HISTORIC PRESERVATION BOARD

HISTORIC PRESERVATION BOARD MEETING

PUBLIC HEARING
99 CAPISIC STREET

Application for: Request to Amend Previously-Approved Plans for Reconstruction of Building 12, including Exterior Alterations, Additions and Site Alterations

DESIGN CHANGES

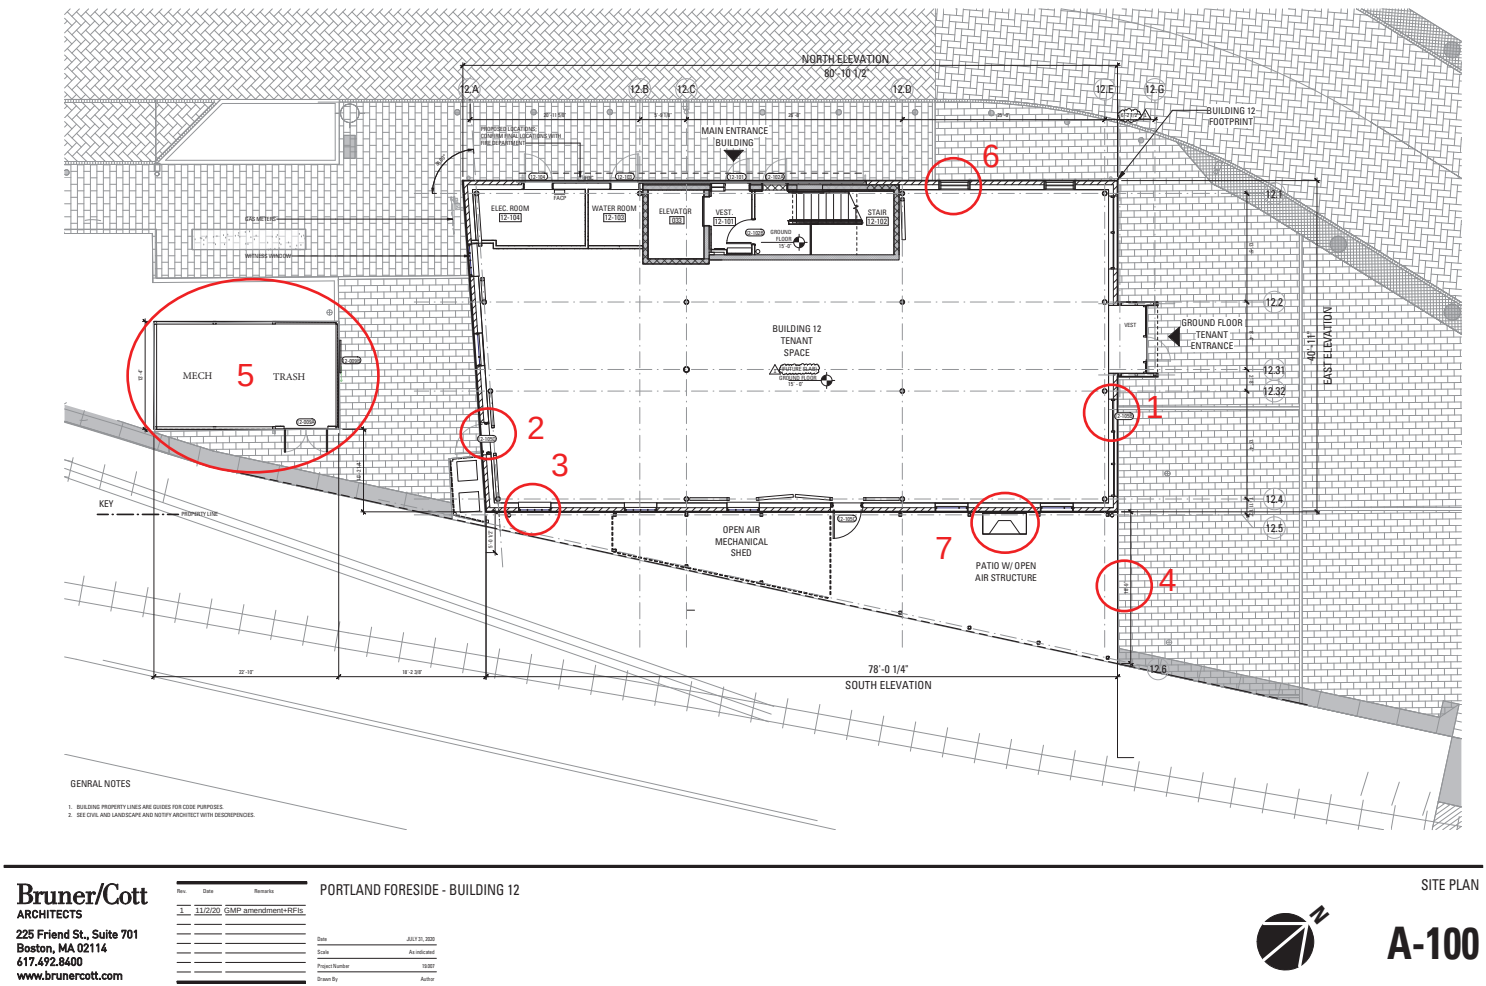
DESIGN CHANGE SUMMARY:

- 1. REVISED EXISTING EXTERIOR DOOR @ STOREFRONT TO HAVE TRADITIONAL FRAME
- 2. MOVED WINDOW AND REPLACED WITH EXTERIOR DOOR
- 3. MOVED EXTERIOR DOOR AND REPLACED WITH HISTORIC REPLICA WINDOW
- 4. ALIGNED EDGE OF PATIO CANOPY WITH PROPERTY LINE- INCREASING WEST END BY 6"
- 5. ENLARGED TRASH ENCLOSURE TO ACCOMIDATE FINAL MECHANICAL EQUIPMENT
- 6. SIMPLIFIED MODERN WINDOW TO CURTAINWALL SYSTEM WITHOUT WINDOW UNIT
- 7. FINALIZED EXTERIOR FIREPLACE AND DELETED FLUE TO TENANT INTERIOR FIREPLACE.

EAST ELEVATION

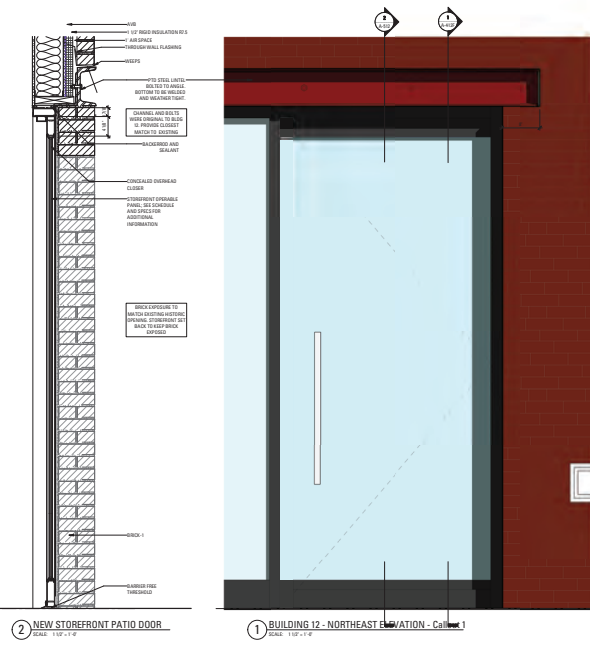
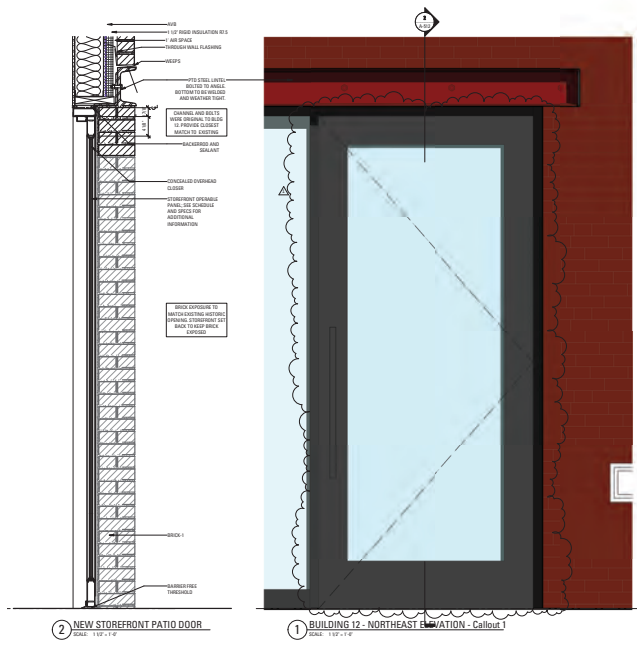
DESIGN CHANGE SUMMARY:

-REVISED EXISTING EXTERIOR DOOR WITHIN STOREFRONT SYSTEM TO HAVE TRADITIONAL FRAME

DESIGN CHANGE- 2

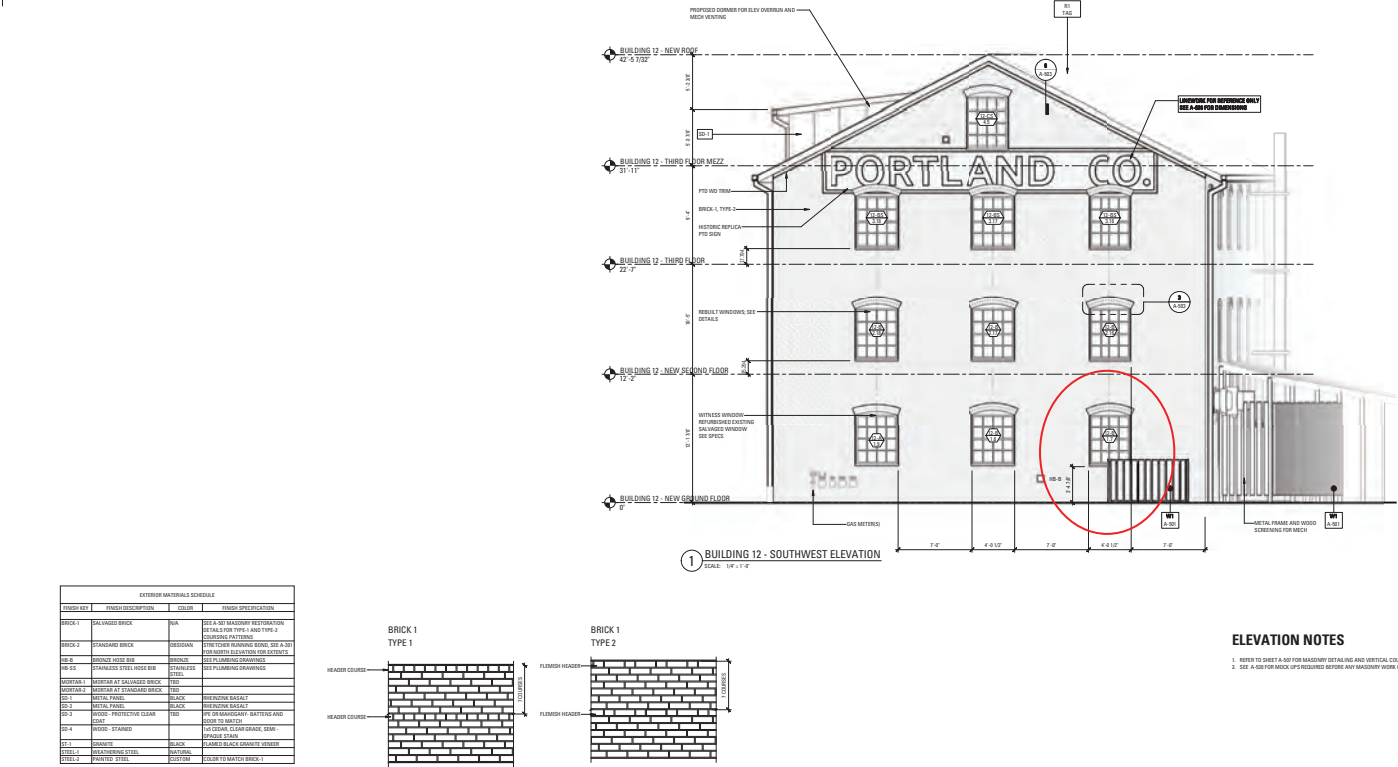
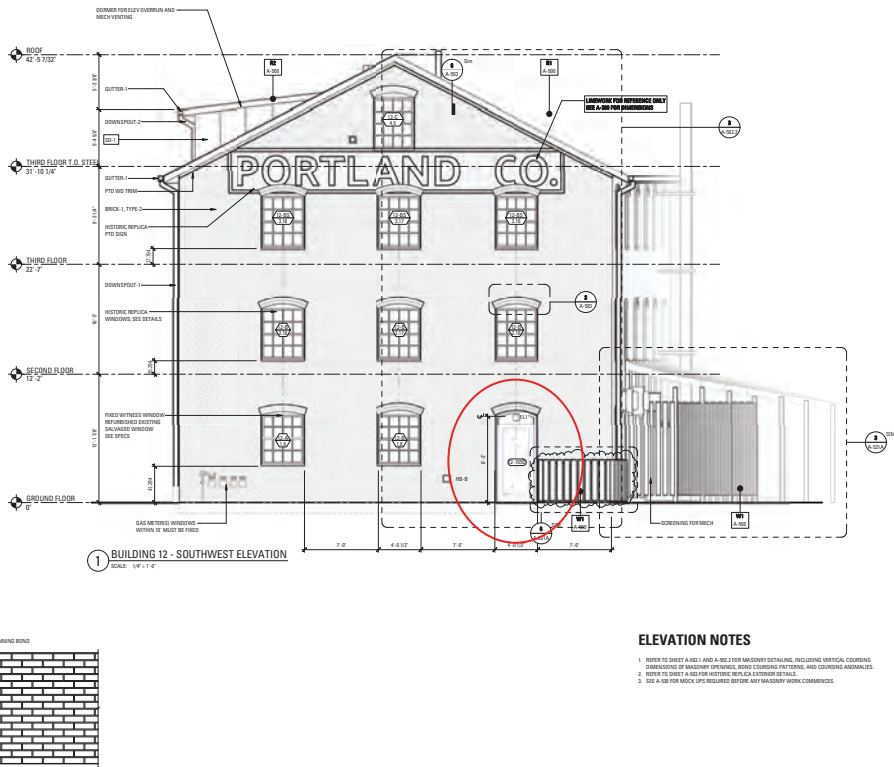
- Proposal to swap the location of the single egress door at the western end of the south elevation to the west elevation. This change also requires shifting the position of the screened mechanicals at the southwest corner to avoid the door.
- Proposal to enlarge and shift the position of the trash/mechanical enclosure structure west of Building 12.

In the approved plans, the only elevation of Building 12 that was to be left in its original (reconstructed) condition was the west elevation. One of the strongest character-defining features of the west elevation is its simplicity—not only in form, but also in its consistent pattern of fenestration. This elevation is also the most prominent, at least as viewed from Thames Street. The proposed swap in door location from the south elevation to the west elevation results in the alteration of this key elevation. (That said, with the swap the original first floor window on the south elevation will be retained.) The Board will need to assess the relative impact of this alteration on the character of the historic structure and whether ordinance Standards #2 and #5 have been met.

DESIGN CHANGE 3

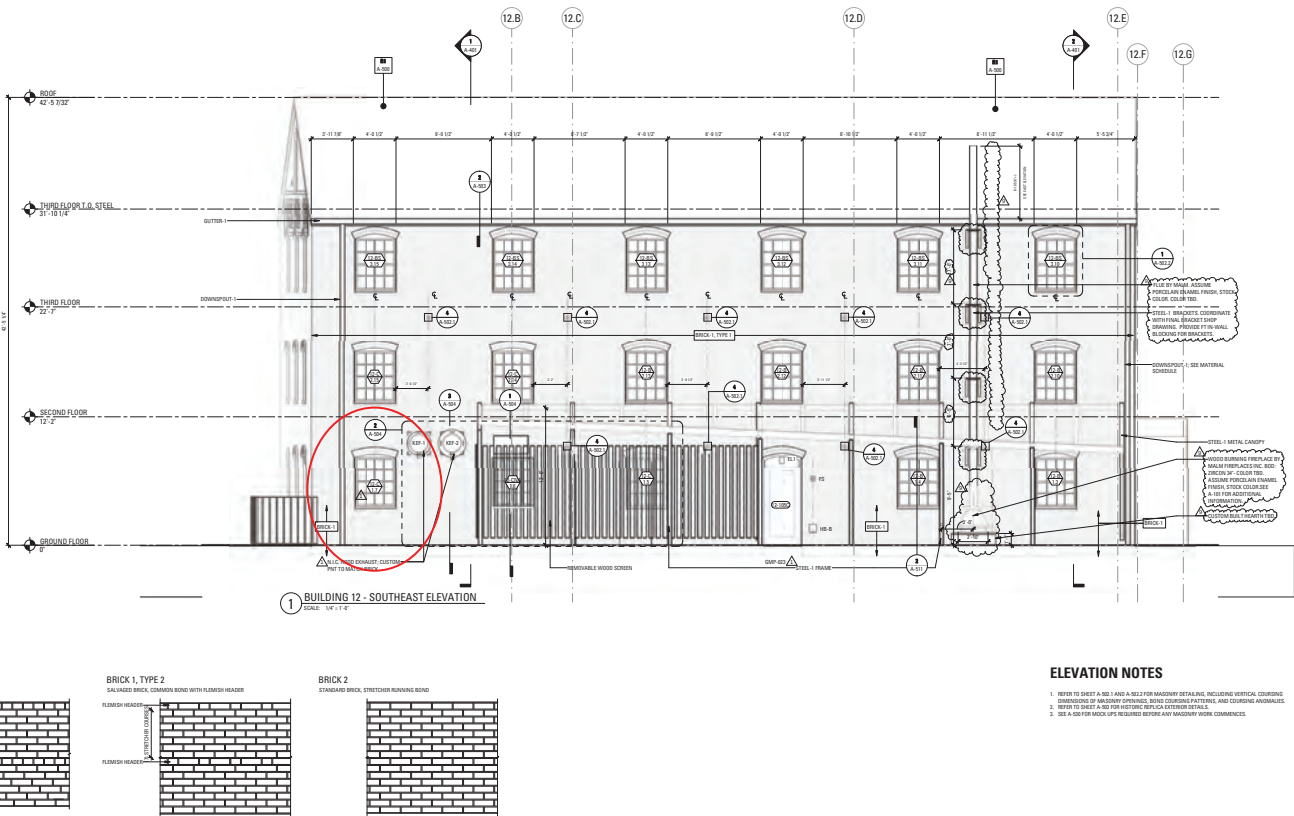
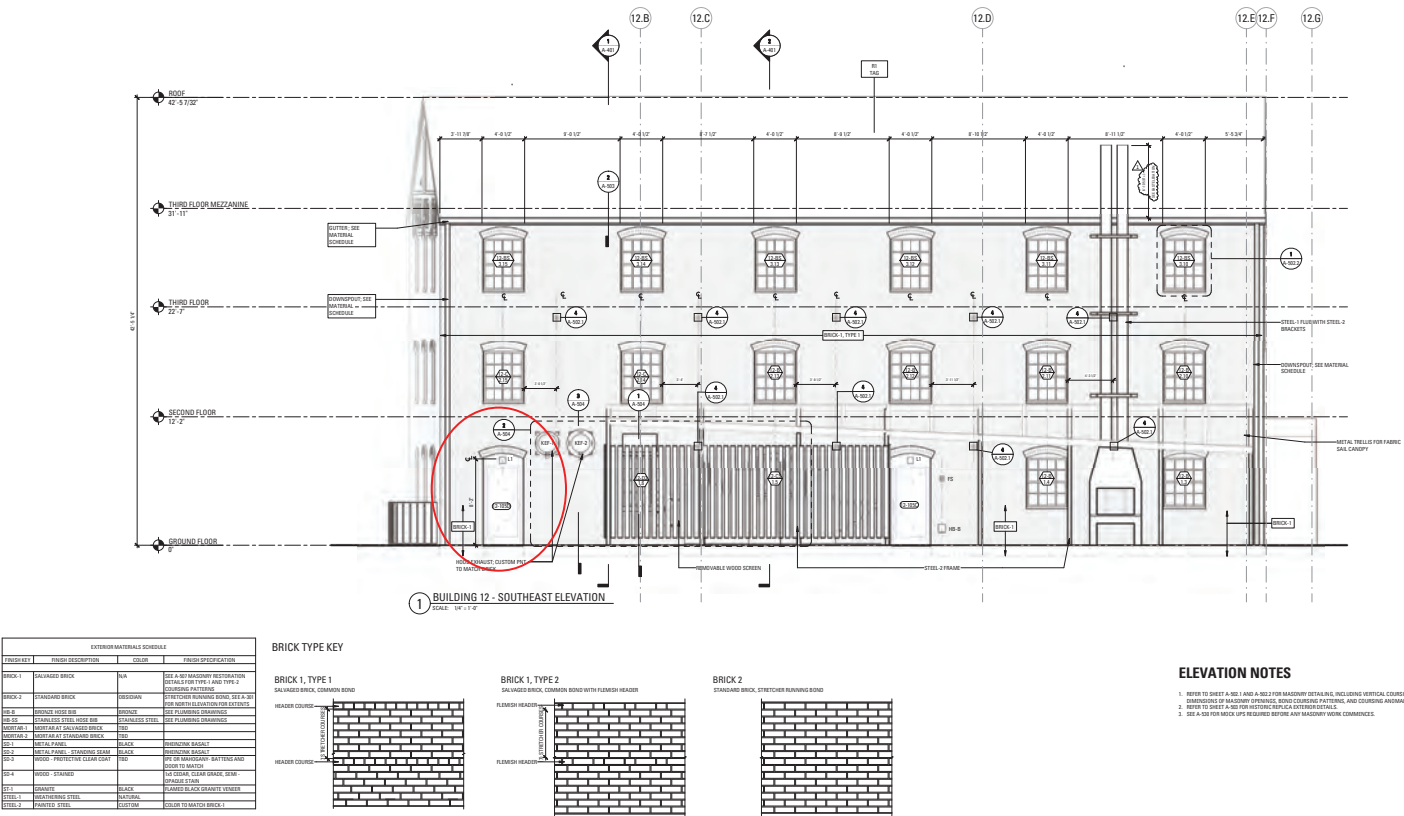
- 3) Modified the planned egress door on south elevation to a historic replica window due to property line and exterior egress constraints;
- 4) Aligned the edge of the patio canopy on the west elevation with the property line, increasing the canopy depth by 6 inches;

DESIGN CHANGE- 7

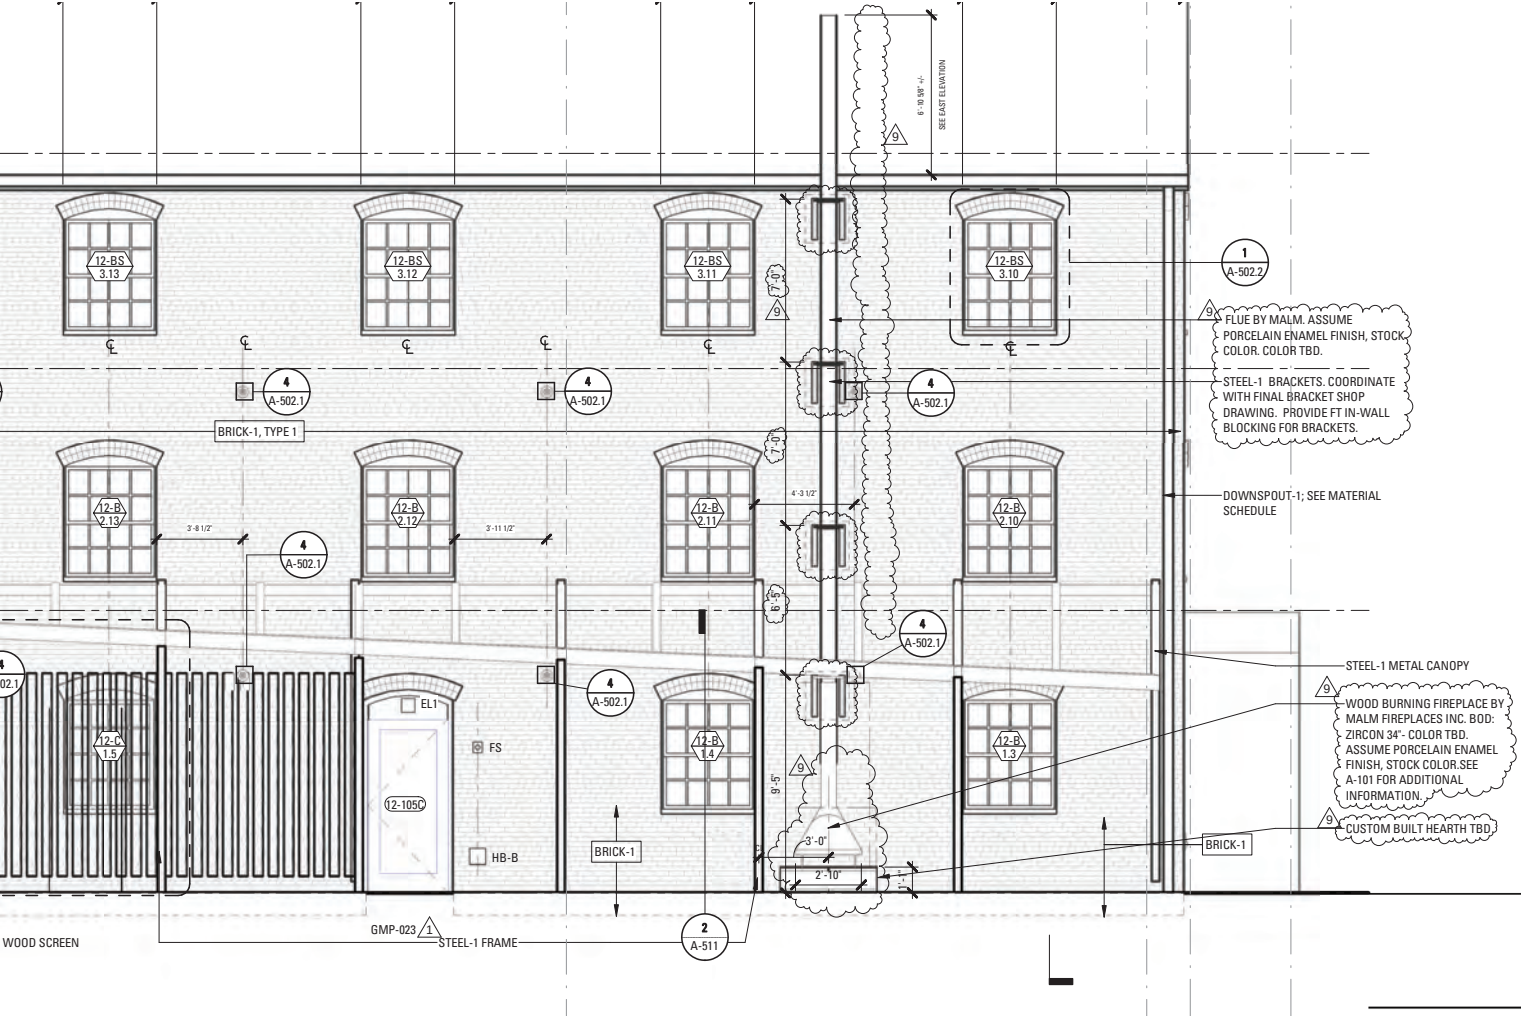
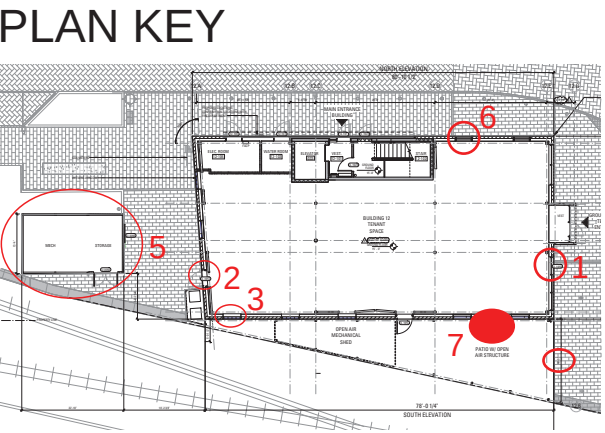
- DESIGN CHANGE SUMMARY:**
- FINALIZED THE OUTDOOR FIRE-PLACE. SELECTED A SMALLER NON-CUSTOM PRODUCT.
 - REMOVED (1) FLUE AT THE EXTERIOR/ADJUSTED THE BRACKETS

Figure 001 – Planting Plan

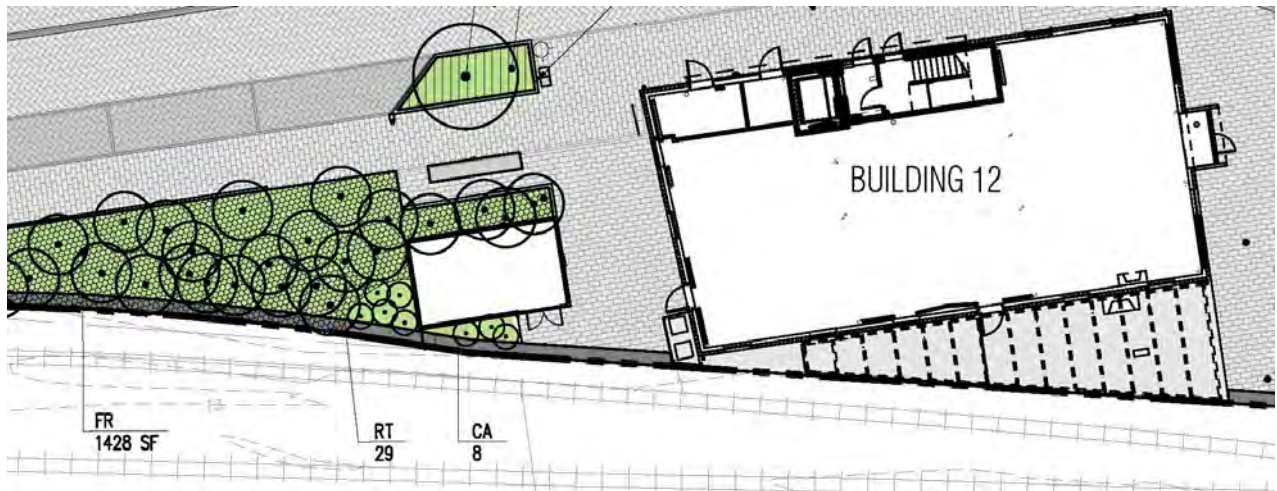
Relative to the recent updated Building 12 submittal from PFDC and Bruner Cott, the following statement and Figure 001 on page 2 provide additional information on the plantings near Building 12.

The plant list remains unchanged from the original submittal. The plant locations have been adjusted slightly to accommodate the architectural updates. The plants adjacent to, and surrounding, the accessory building are as follows;
